FINDLAY CITY PLANNING COMMISSION

STAFF REPORT December 10, 2020

1. **APPLICATION FOR SPECIAL REVIEW #SR-01-2020 filed by Taco Fiesta Hinojosa, 307 Edinborough Drive, Findlay for a pick up window at 224 N Main Street, Findlay.**

3. PRELIMINARY PLAT APPLICATION #PP-01-2020 for Hickory Lake 4th Addition.

SR-01-2020

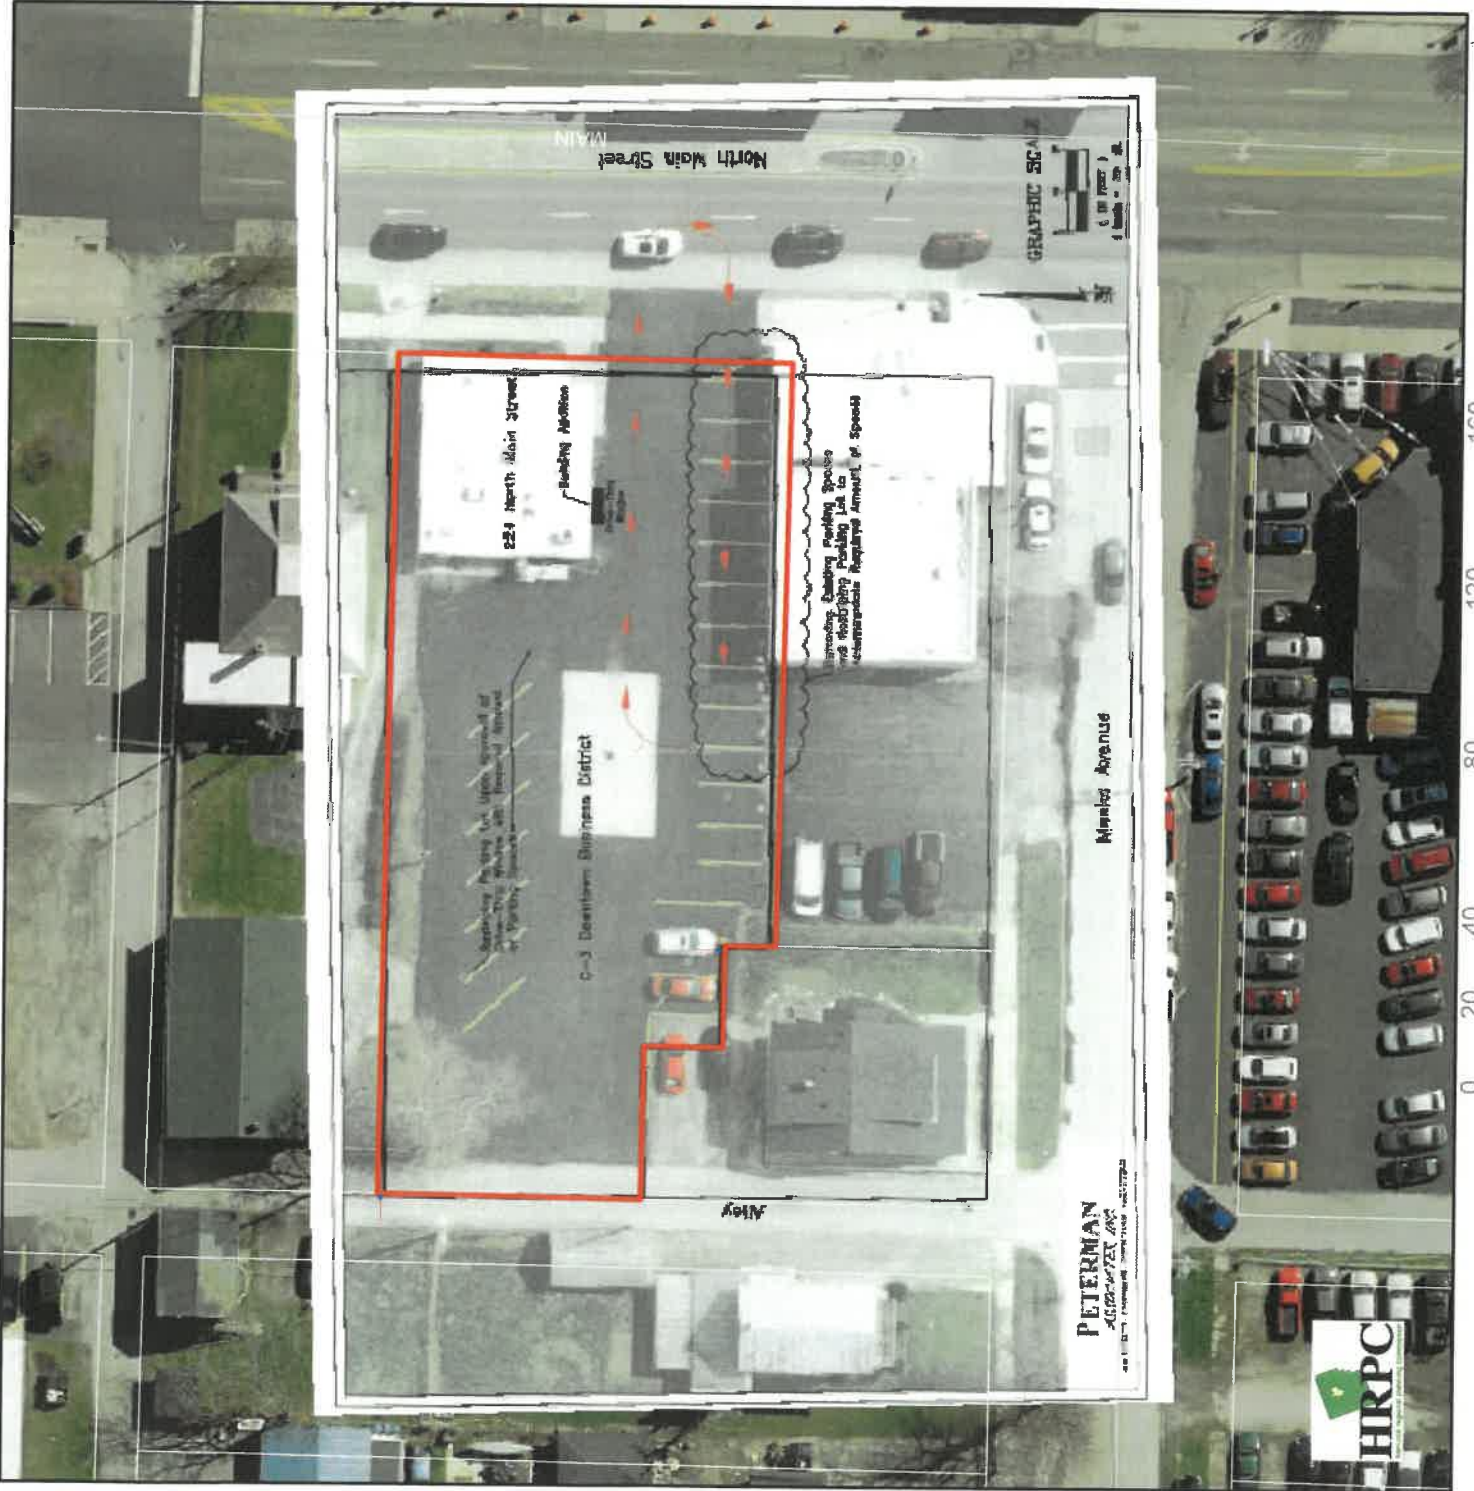
From the illustration presented, there are 10 parking spaces which will be eliminated to make way for a drive path to the pick-up. It was not indicated whether there will be some indoor dining space. The site can still meet the minimums as far as required parking is concerned although they are probably not that convenient for customers wishing to come into the business.

There had been a pick up window on the rear of the building at one time. We would assume it was entered by the drive on the north side of the building to make it work. This would have been problematic as well since a car would have difficulty seeing what traffic was entering from Main Street around the corner of the building.

Engineering has several concerns with the proposed traffic circulation pattern to provide access to the drive thru window.

First, since the median has been installed on Main Street, the northbound traffic does not have access to the existing drive and will need to turn left onto Meeks Avenue and then turn right onto

the alley and then right onto the property. While engineering does not necessarily have an issue with this, it could result in a conflict point if there are more than 3 or 4 cars waiting in line.

Second, the southbound traffic will turn right onto the property. The existing building is located on the property line, which means there is less than 20 feet from the face of the building to the curbline. The natural instinct of the driver will be to turn into the right side of the drive. With the location of the building, the driver will not be able to see if there is a vehicle leaving the drive thru window. A pavement arrow could be placed on the pavement but that does not mean that the driver will see it in time to enter the south side of the drive.

Third, there would also be an issue if a driver is leaving the parking lot and a second driver is leaving the take out window. This would create a conflict point where one of the drivers would have to merge and the driver leaving the window may not see the other vehicle coming up behind them. This situation would only get even more confusing if someone is also trying to turn into the parking lot while the other drivers are leaving.

The fourth concern is that the proposed turn around to access the drive thru window is tight. Larger vehicles such as pickup trucks, SUVs, etc. will have issues making the turn without having to back up and make a three point turn.

The final concern is the stacking at the window. No menu board is shown, so it is assumed that the customers will be ordering at the window and then waiting for their food. Assuming a 20 foot vehicle length, the circulation pattern shown, and scaling off of the drawing, the required 8 car stacking would extend all of the way back to the right of way line. This would cause issues with accessing the site from Main Street and could result in backups on Main Street.

If a formal site plan were to be submitted for the proposed take out window as shown on the proposed plan, Engineering would not be in favor of approval for the reasons listed above.

Plan must allow sufficient space for our fire apparatus to access the building.
